Access Compliance Report

Public Rights-of-Way

Intersection ID: 4147	Main Street: DAVIS_LAKE_PY	Cross Street: SAGEWOOD_PL	Location: SE
ADA ID: A1FBF8B6EB7D	Ramp Type: Perp	Initial Pass/Fail: Fail	Overall Compliance: No
Severity Score: 33.75			
Codes/Mitigation Info/Possible Solution		Field Measurements/Component Compliance

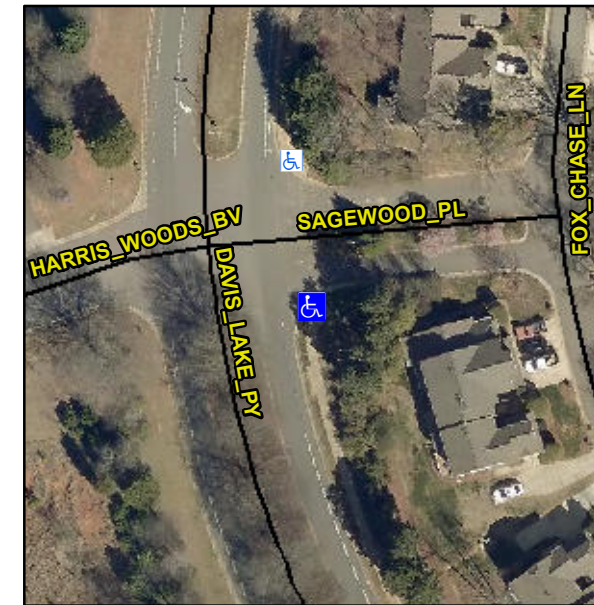
R304.5.1, R304.5.3

Compliance	Description	Data	Compliance	Description	Data
N/A	Ramp Length (in)	48.0	Yes	Ramp Slope (%)	5.4
No	Ramp Width (in)	39.0	No	Ramp XSlope (%)	10.4
N/A	Flare Type LT	N/A	N/A	Flare Type RT	N/A
N/A	Flare Slope LT (%)	N/A	N/A	Flare Slope RT (%)	N/A
N/A	Flare Traversable LT?	N/A	N/A	Flare Traversable RT?	N/A
N/A	Landing Length (in)	N/A	N/A	DWS Provided?	N/A
N/A	Landing Width (in)	N/A	N/A	DWS Contrast?	N/A
N/A	Landing Slope (%)	N/A	N/A	DWS Length (in)	N/A
N/A	Landing X Slope (%)	N/A	N/A	DWS Full Width?	N/A
N/A	Landing Curb? (Y/N)	N/A	N/A	DWS Offset (in)	N/A
N/A	Shared Landing?	N/A			
N/A	Gutter Ponding?	N/A	N/A	Gutter Slope (%)	N/A
N/A	Gutter Lip Ht (in)	N/A	N/A	Gutter X Slope (%)	N/A
N/A	Painted X Walk1?	No	N/A	Painted X Walk2?	N/A
	X Walk 1 Direction	To N		X Walk 2 Direction	N/A
N/A	X Walk 1 Width (in)	N/A	N/A	X Walk 2 Width (in)	N/A
	X Walk 1 Slope (%)	3.5		X Walk 2 Slope (%)	N/A
	X Walk 1 X Slope (%)	7.6		X Walk 2 X Slope (%)	N/A

Remove & Replace Entire Ramp.
